**CENTRAL WATERFRONT BOARDWALK
RECONSTRUCTION**

**ADDENDUM No.1
July 13, 2026**

PROPOSED SECTIONS -
SHEET 1 OF 2

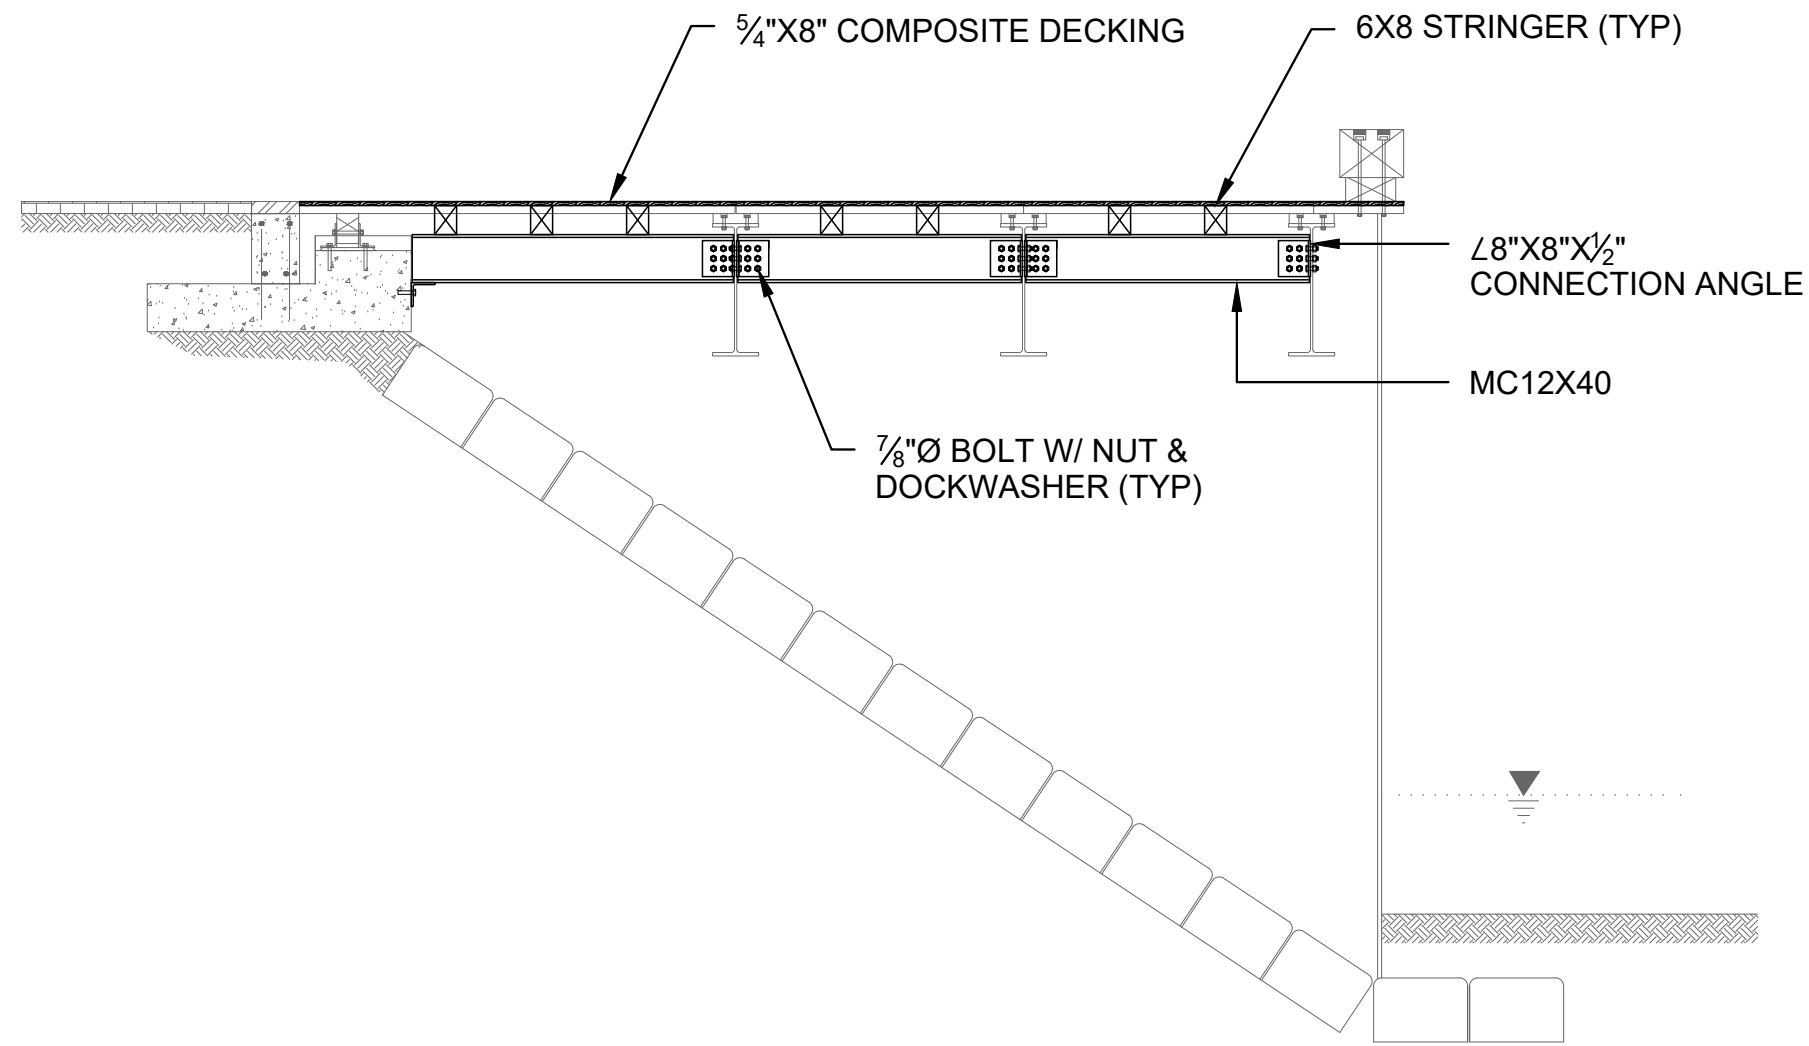
1. G-002 General Notes. Sequence and phasing of work is deleted.
2. S-301 Proposed Sections Sheet 1 of 2: Detail added for reconnection of Ipe decking to stringers
3. S-302 Proposed Sections Sheet 2 of 2: Plan added for bridge
4. S-501: Clarification added to indicate butyl tape shall be applied to the top of all stringer and pile cap horizontal faces.

I PLAN
STEEL BRIDGE BOARDWALK SCALE: 1" = 50'

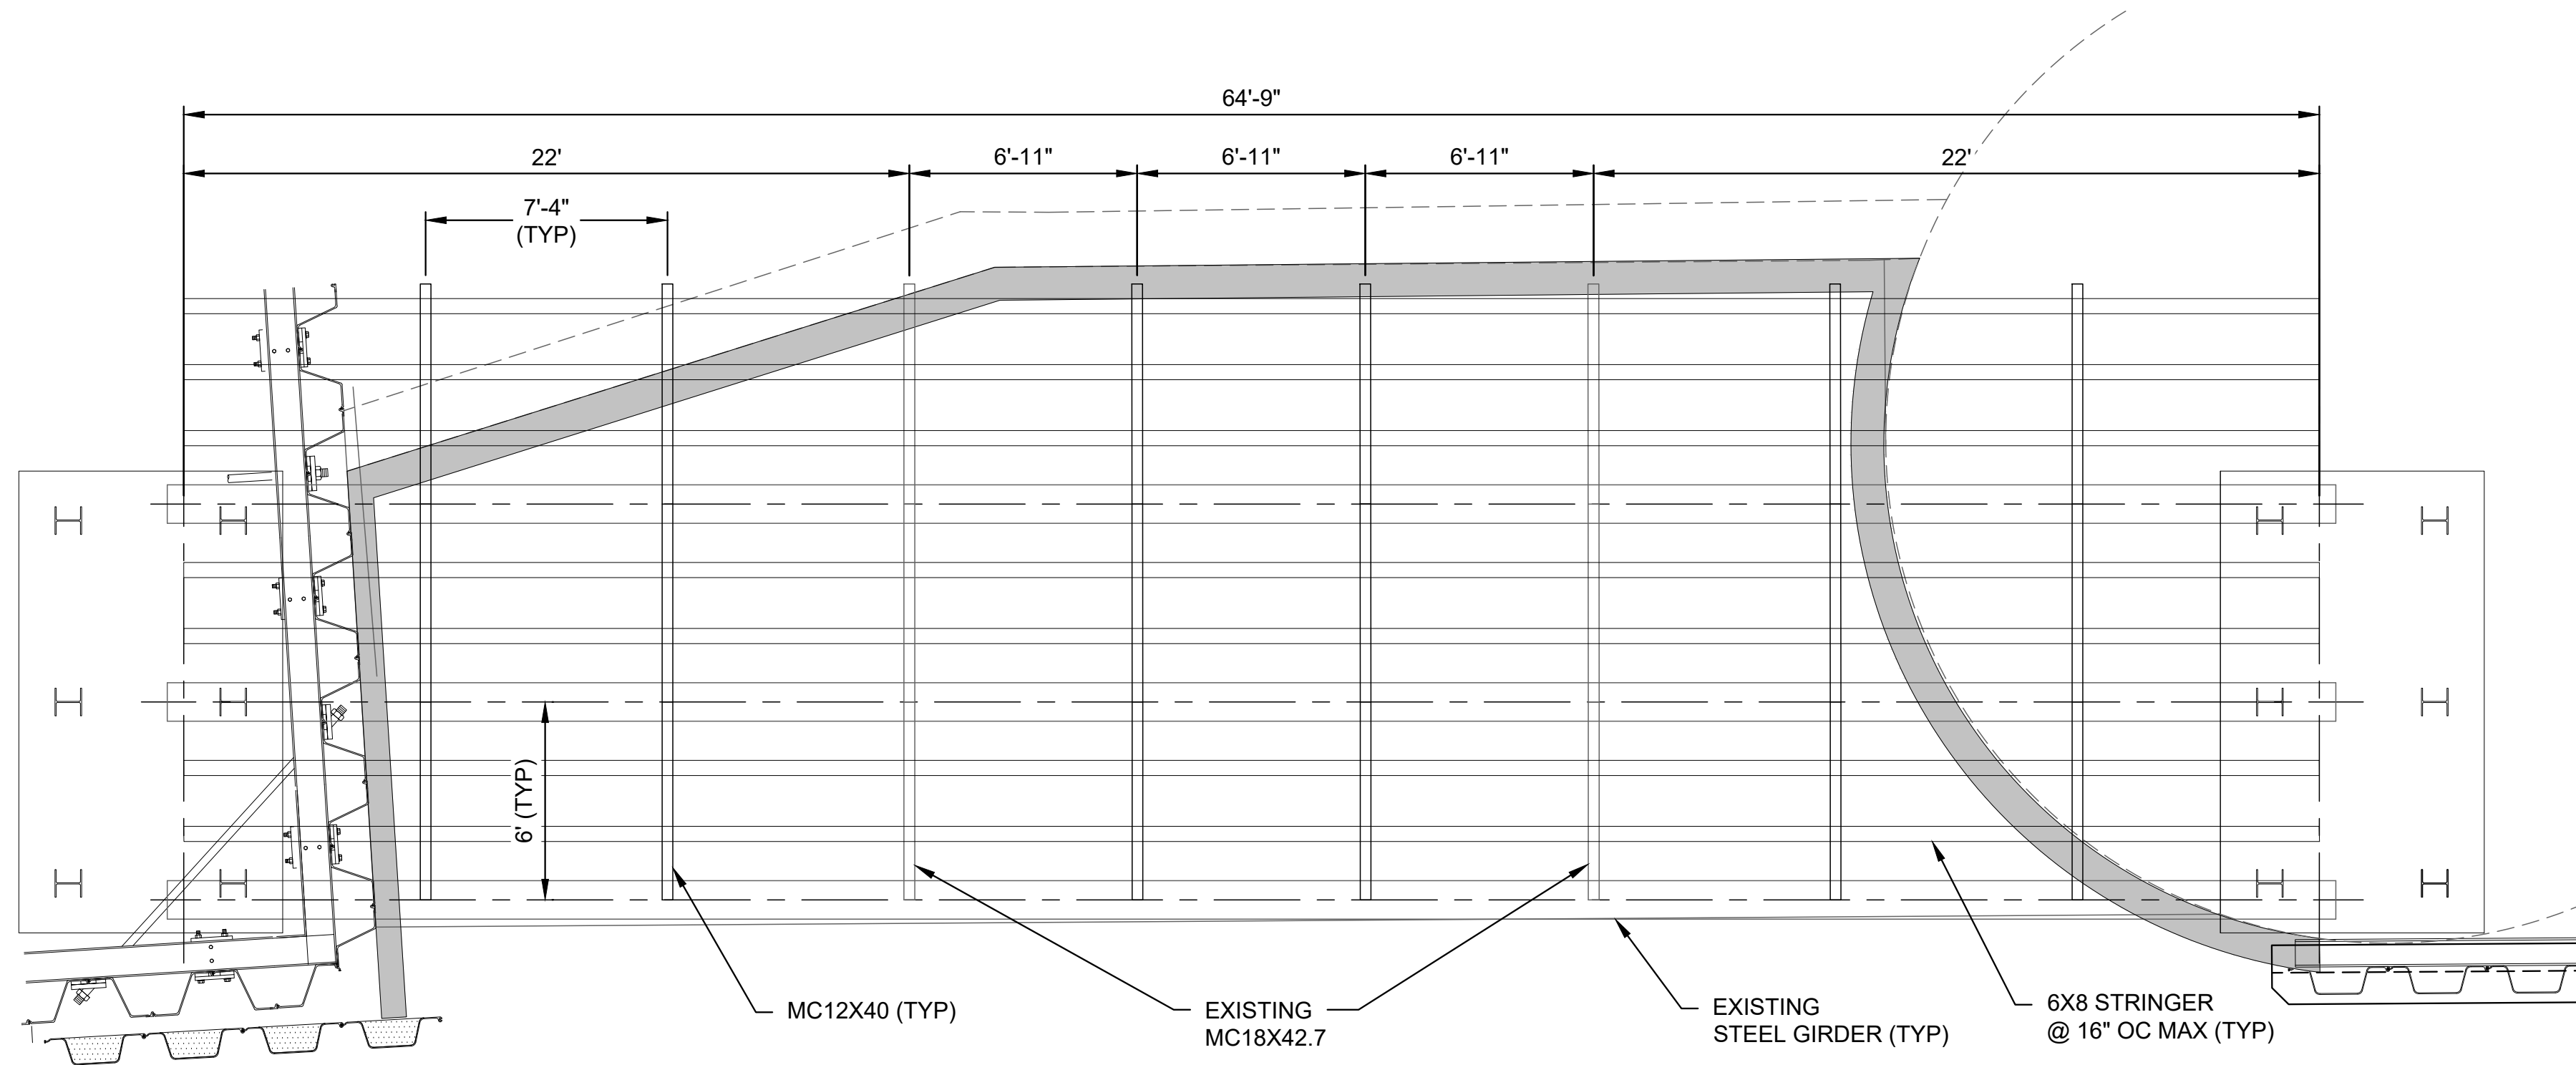
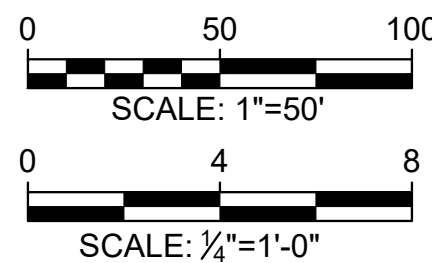
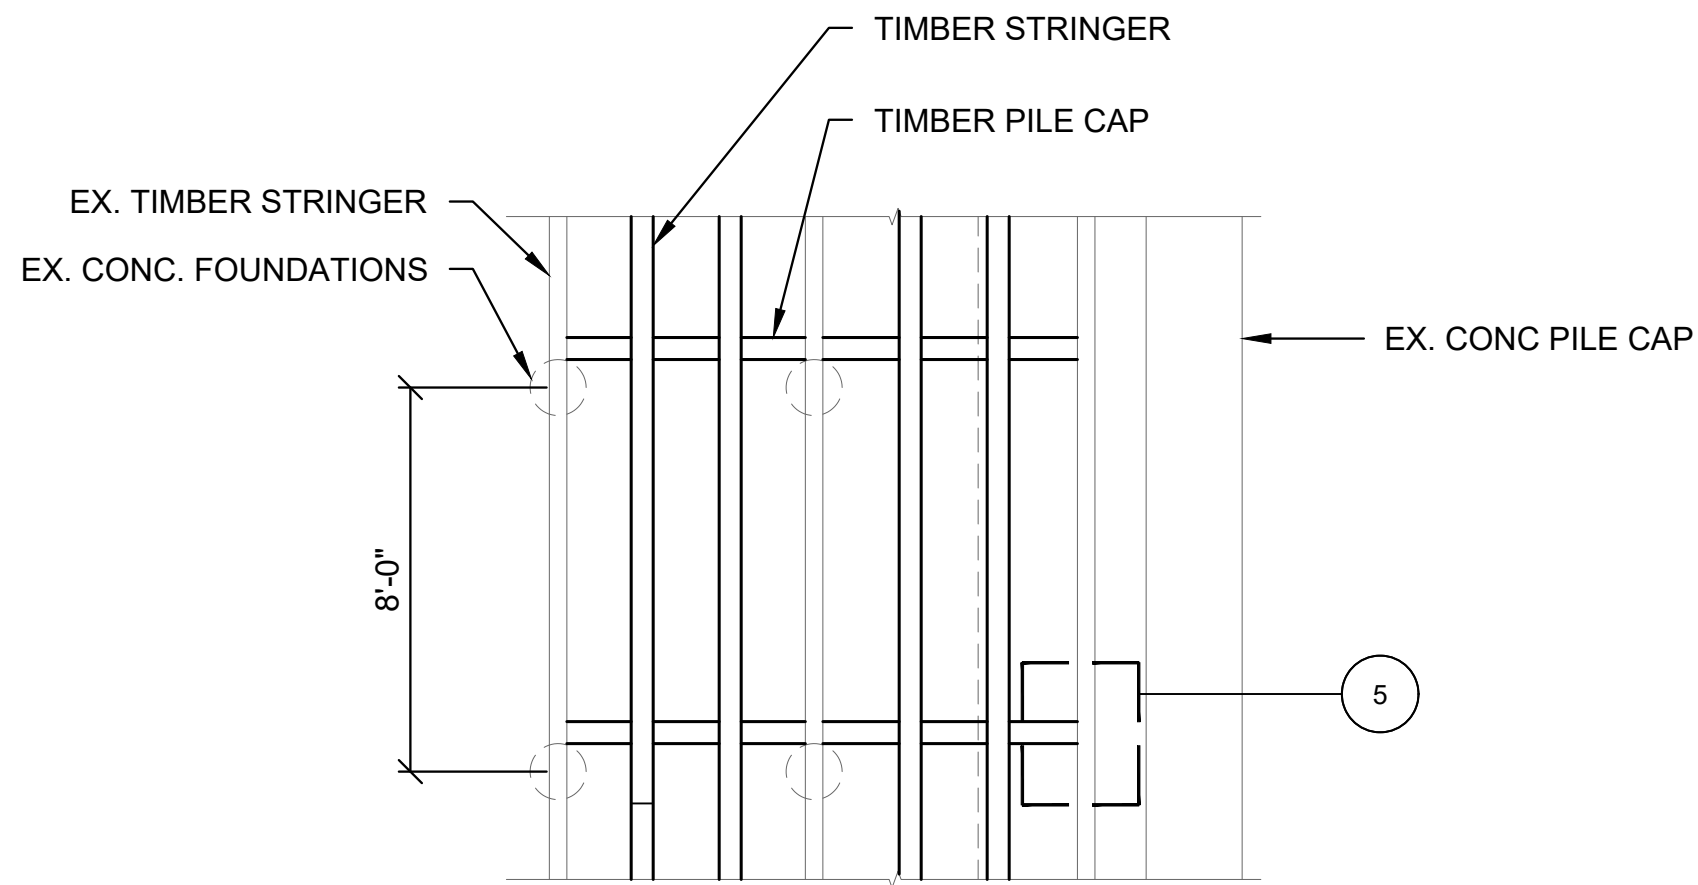
1. Can we get an aerial/plan detail view of the bridge section.

Response 1: Yes a plan view of the bridge section will be provided.

5 DETAIL
PILE CAP CONNECTION
SCALE: 1/4" = 1'-0"

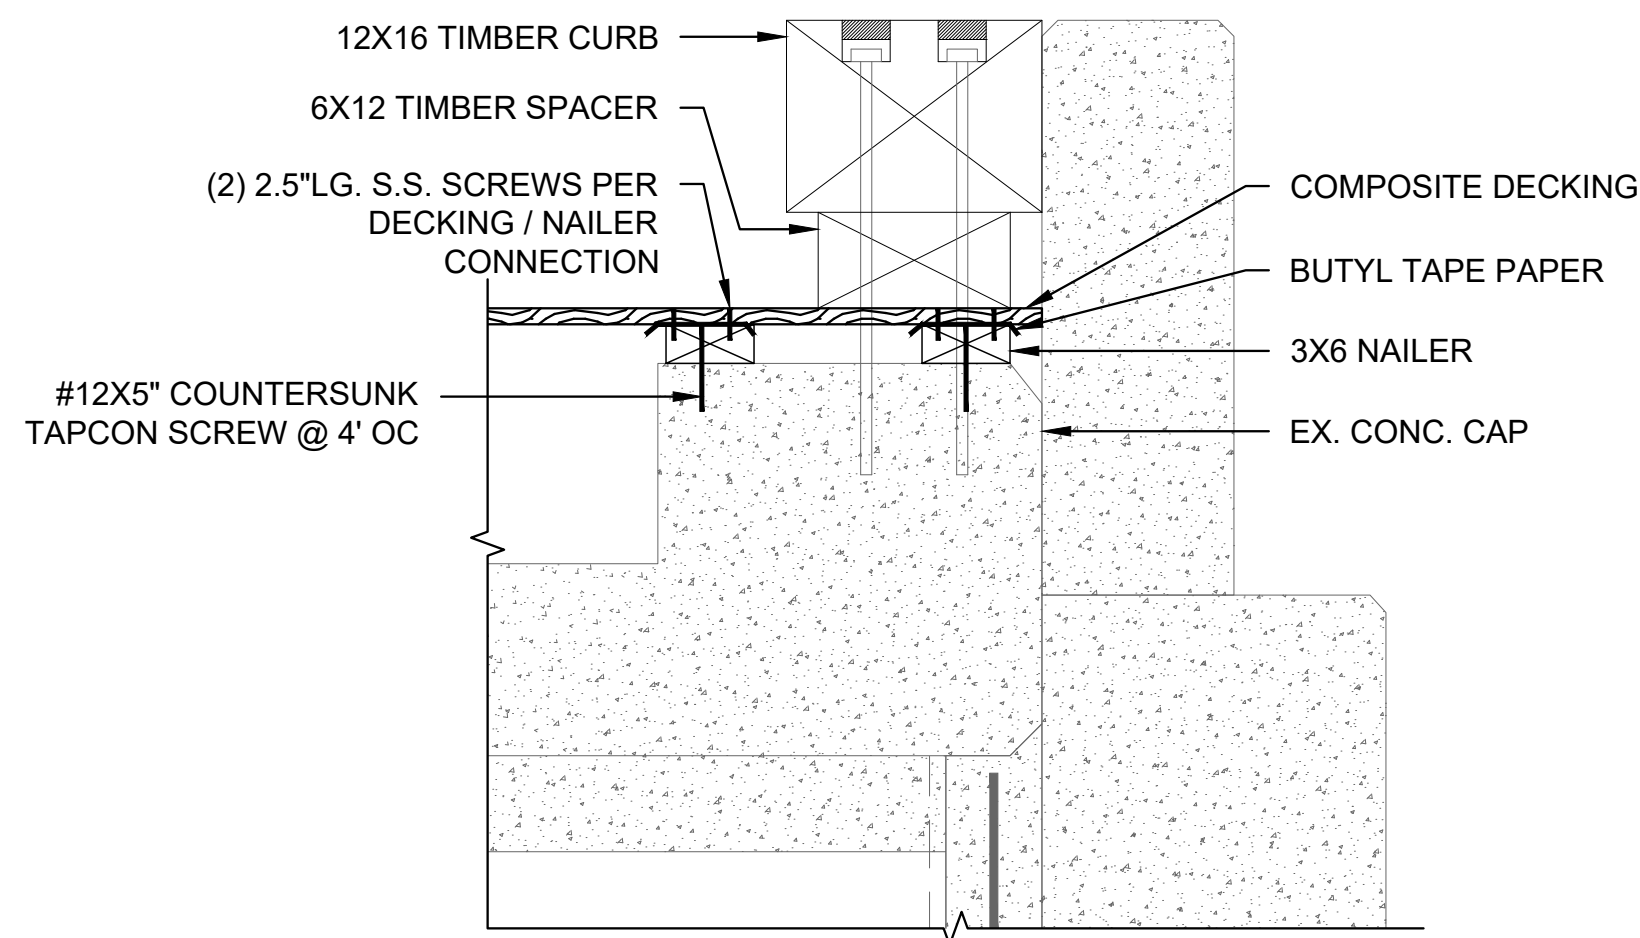
2. Drawing S-501 detail 5 shows one bracket on the side of the 6x6, seems that it should be on both sides. Please confirm.

Response 2: The single bracket in the 6x6 is acceptable.
